寄件者: [REDACTED]  
寄件日期: 2025年06月25日星期三 11:53  
收件者: tpbpd/PLAND  
副本: David Chi Chiu CHENG/PLAND  
主旨: S.16 Planning Application No. A/YL-KTN/1114 - Departmental Comments  
附件: AYL-KTN 1114 20250625.pdf  
類別: Internet Email

**有關城市規劃委員會對 A/YL-KTN/1114 的查詢**

**有關對運輸署 A/YL-KTN/1114 的查詢**

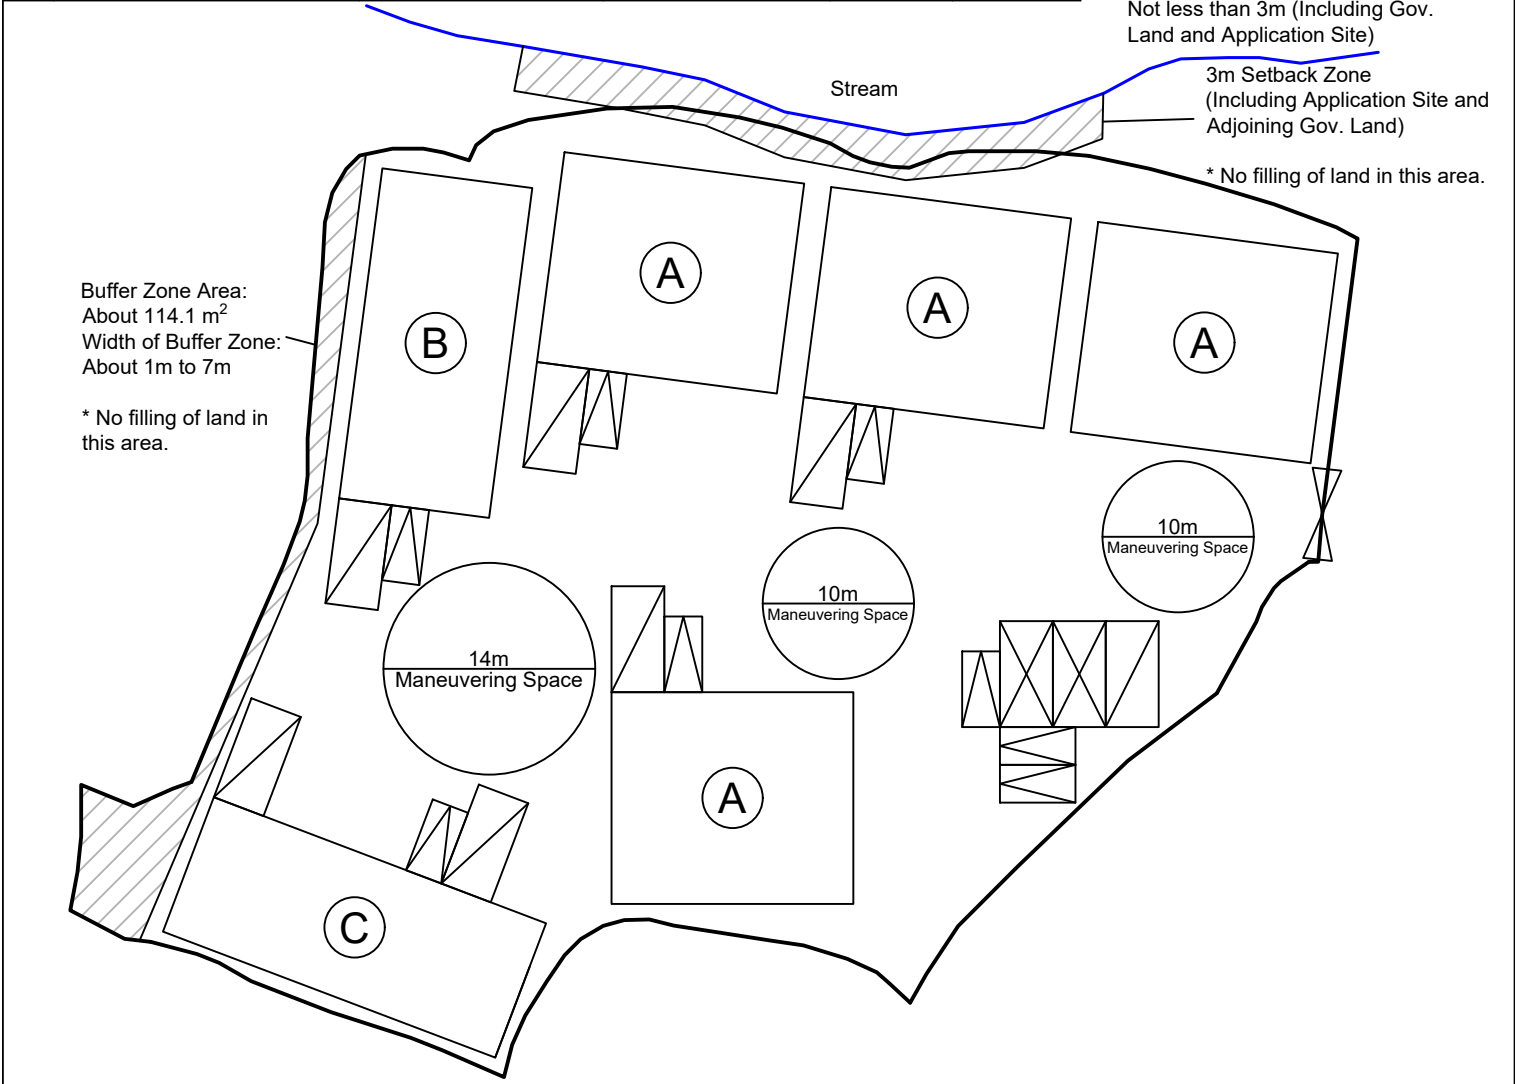
申請地點有道路連接，前往本申請地點途經水尾路，再轉到郊區小徑到達申請地點。水尾路沿途道路約有 3-5 米闊，並設有避車處，私家車及客貨車有足夠的位置通過及進行調遣的動作。申請地點的出入口約 5.5 米闊。

連接本申請地點的郊區小徑為私人道路，本人已獲得有關地段的擁有人及其持分者同意使用相關地段作出入通道，此通道亦會用作緊急用途。

在申請地點內有一個直徑超過 14 米及兩個直徑超過 10 米的圓形空間，足夠讓車輛進行調遣的動作，進入本申請地點的車輛不會在公用道路上讓車輛等候進入本申請地點，停泊在公用道路及以倒後形式進出本申請地點。參考文件末端的 Appendix 2。
